MWRA ANNUAL REPORT
FOR CALENDAR YEAR 2023

Re: Comments on the draft Deer Island Treatment Plant and Combined Sewer Overflow NPDES Permit (MA0103284) and Draft Surface Water Discharge Permit: Deer Island Treatment Plant (MA 0103284)

MWRA Comments on the draft Deer Island Treatment Plant and Combined Sewer Overflow NPDES Permit (MA0103284) and Draft NPDES Surface Water Discharge Permit: Deer Island Treatment Plant (MA 0103284)

Figure 1. Maximum per survey counts of *Pseudo-nitzschia* spp. in the nearfield. Cell counts made using the whole water method. Solid grey line is the 15,000 cells/L EPA-proposed threshold for rapid response surveys. The dashed line is the 30,000 cells/L threshold used by DMF.

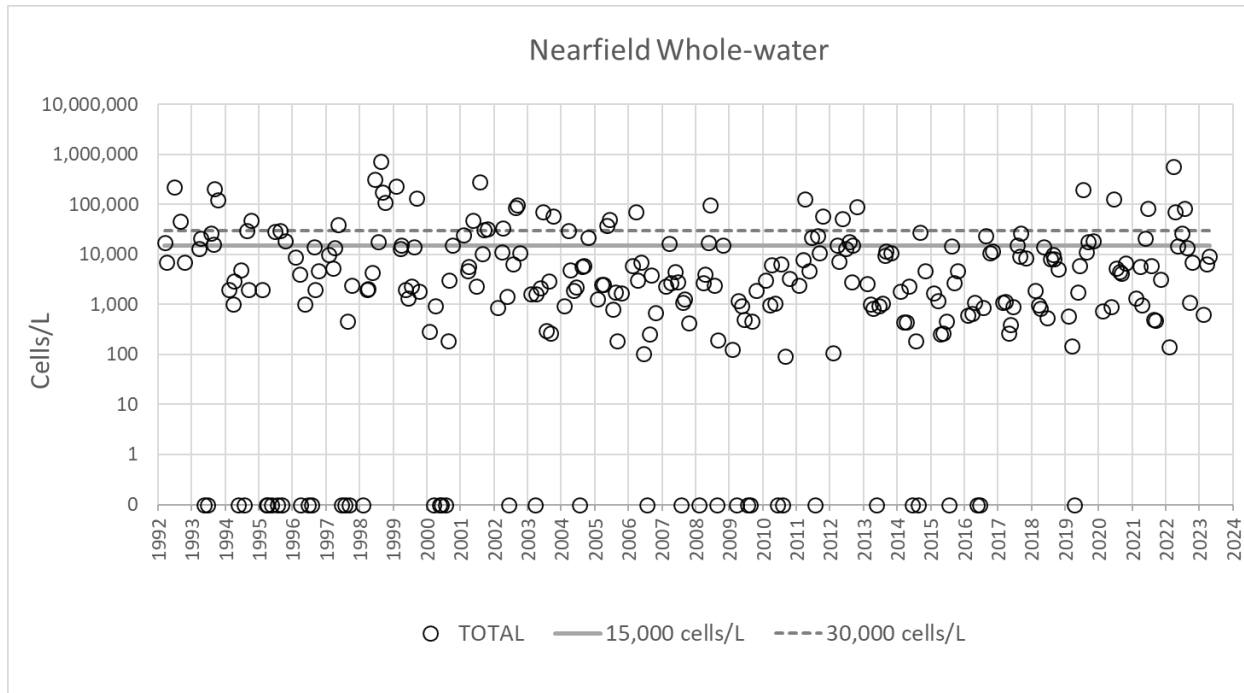
Historically, 2016 was the only year that ASP closures were in effect in Massachusetts Bay. MWRA's data also show that the *Pseudo-nitzschia* cell counts were not particularly high that year in either the outfall nearfield or farfield. In fact, a number of years have had numerous counts above the Draft Permit threshold, with no historical evidence of ASP. Figures 1 and 2 show the highest *Pseudo-nitzschia* count per survey in the nearfield and farfield, respectively. The counts are from the quantitative whole water method. The solid grey line represents EPA's proposed 15,000 cells/L threshold. The data span 1992 – early 2023. There are a number of exceedances of the threshold throughout the period, and the majority of the highest counts were in 1998-99, before the outfall went into operation. As a reminder, the only shellfish closure for ASP in Massachusetts Bay was in 2016, when *Pseudo-nitzschia* cell counts were not comparatively high.

Figure 2. Maximum per survey counts of *Pseudo-nitzschia* spp. in the farfield. Cell counts made using the whole water method. Solid grey line is the 15,000 cells/L EPA-proposed threshold for rapid response surveys. The dashed line is the 30,000 cells/L threshold used by DMF.

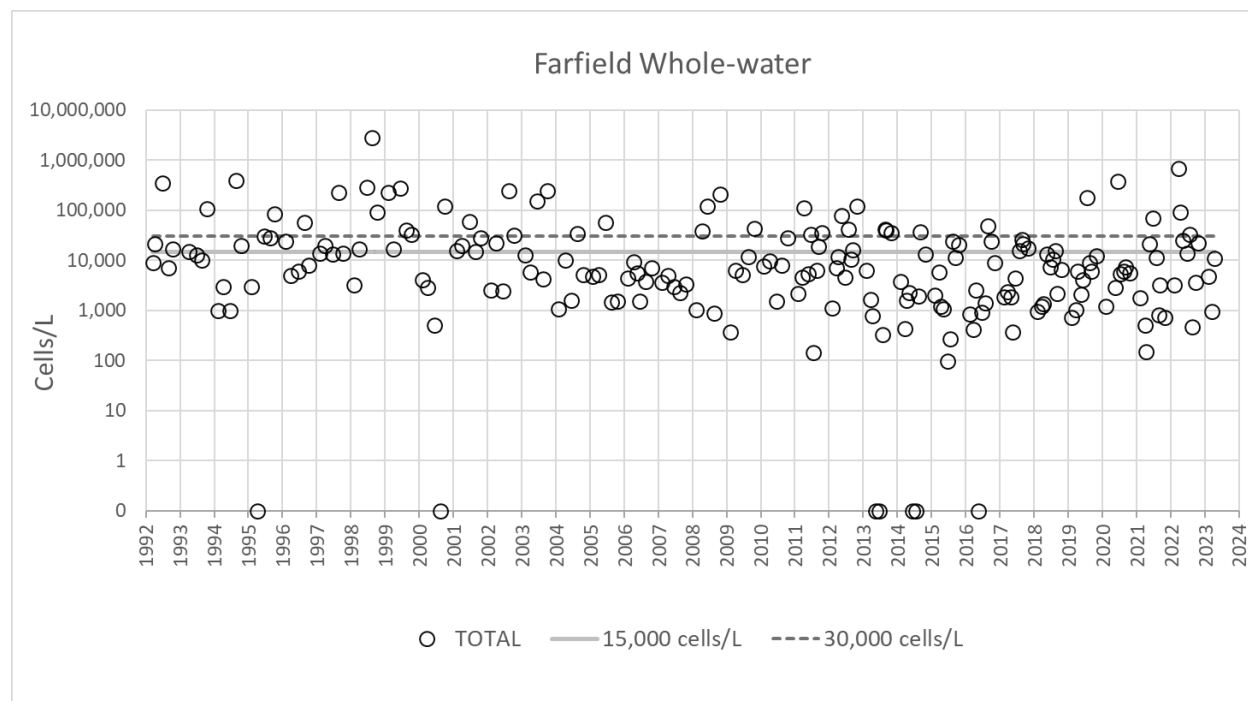
As currently written in the Draft Permit, a scenario could occur where MWRA conducts intensive rapid response surveys in response to high cell counts while DMF has not declared a consumption advisory for ASP and/or closed shellfishing areas. This situation could lead to confusion among the public and stakeholders as to the safety of shellfish. DMF is the proper lead agency for these decisions, not MWRA. Additionally, a threshold level of 15,000 cells/L could result in numerous costly rapid response surveys with no clear benefit to the public or the environment.

Figure 3. Distribution of *Karenia mikimotoi* bloom abundance levels (cells/L) associated with harmful effects on marine life.⁸²

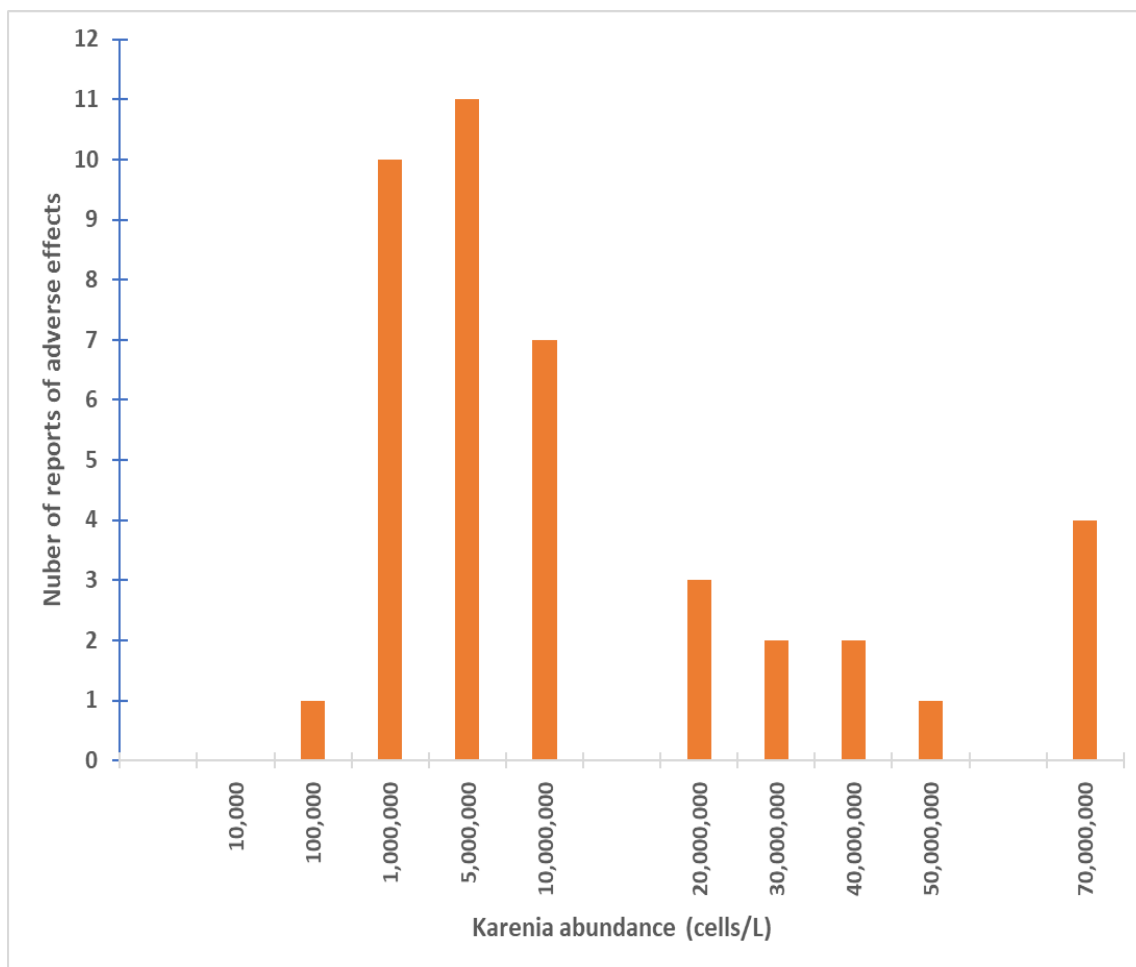
A review of *Karenia mikimotoi* by Li et al⁸¹ compiled *Karenia* abundance for 41 blooms that were associated with adverse effects on marine life (defined as finfish, shellfish, benthic invertebrates; see Li et al, Table 1). An analysis of these data showed that harmful effects due to *Karenia* blooms predominantly occur at cell abundance levels of greater than 1,000,000 cells per liter (see Figure 3). The minimum *Karenia* abundance associated with harmful effects – and the only incident associated with less than 1,000,000 cells/L – was a bloom of 100,000 cells/L. This clearly indicates that the 10,000 cell/L threshold proposed in the Draft Permit is too low by at least one order of magnitude. **Since most harmful effects associated with *Karenia mikimotoi* blooms are associated with abundance of one million cells/L or greater, the Permit threshold for *Karenia mikimotoi* should be set to 500,000 cells/L.**

MWRA does not agree with the requirement for response surveys for *Karenia mikimotoi*. The Rhode Island Department of Environmental Management,⁸³ the Maine Department of Marine Resources,⁸⁴ and Massachusetts Division of Marine Fisheries⁸⁵ do not consider blooms of *Karenia mikimotoi* a threat to public health. Based on this information, **MWRA requests that the response survey requirements be removed from the Permit.**

Figure 1. MWRA Long-Term Regional Flow Data Five Year Running Averages and Five-Year Running Average NOAA Rainfall at Logan Airport

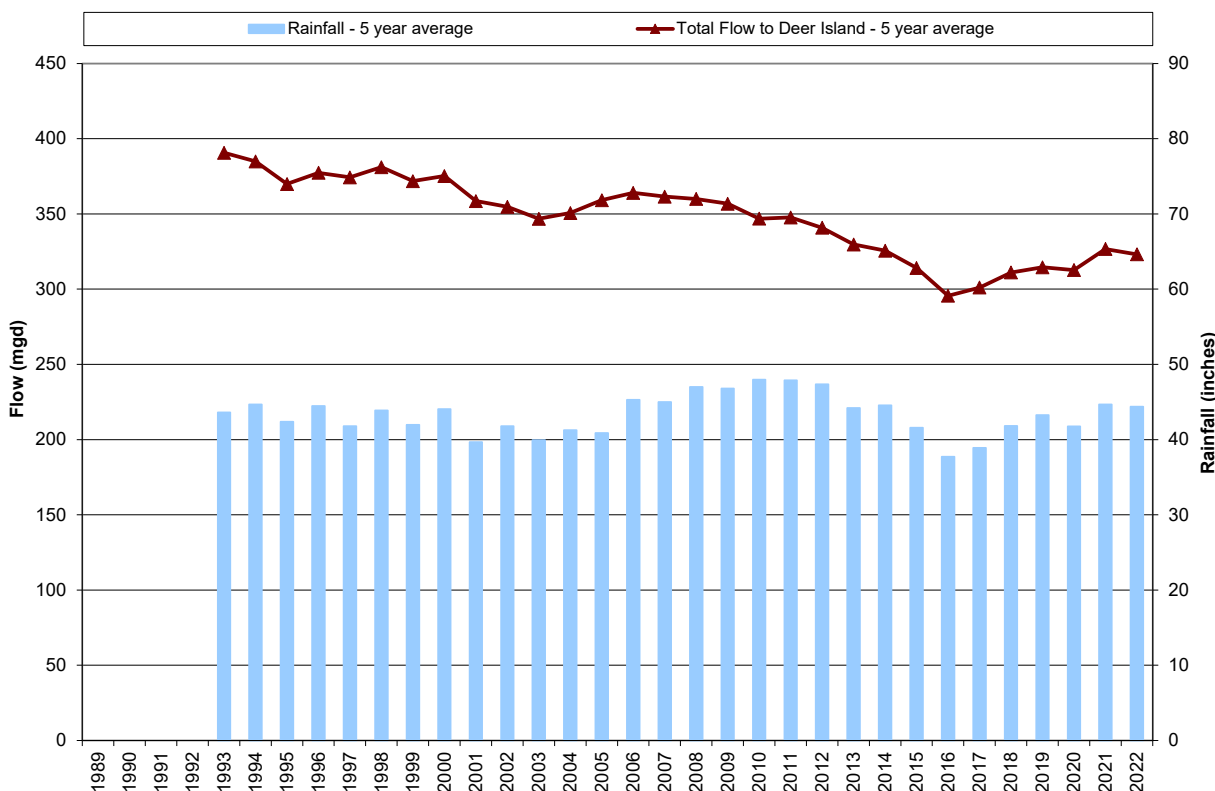
As reported in MWRA’s Annual Infiltration and Inflow (I/I) Reduction Report submission to EPA/MassDEP, and clearly shown in the included wastewater flow graph, MWRA and community efforts to manage I/I have been successful at reducing flows to the system. The five-year running average daily flow has declined from approximately 391 million gallons per day (MGD) in the five year period beginning in 1989 to approximately 324 MGD in the most recent 5-year period, a reduction of 67 MGD or 17% of wastewater flow tributary to the Deer Island Treatment Plant.
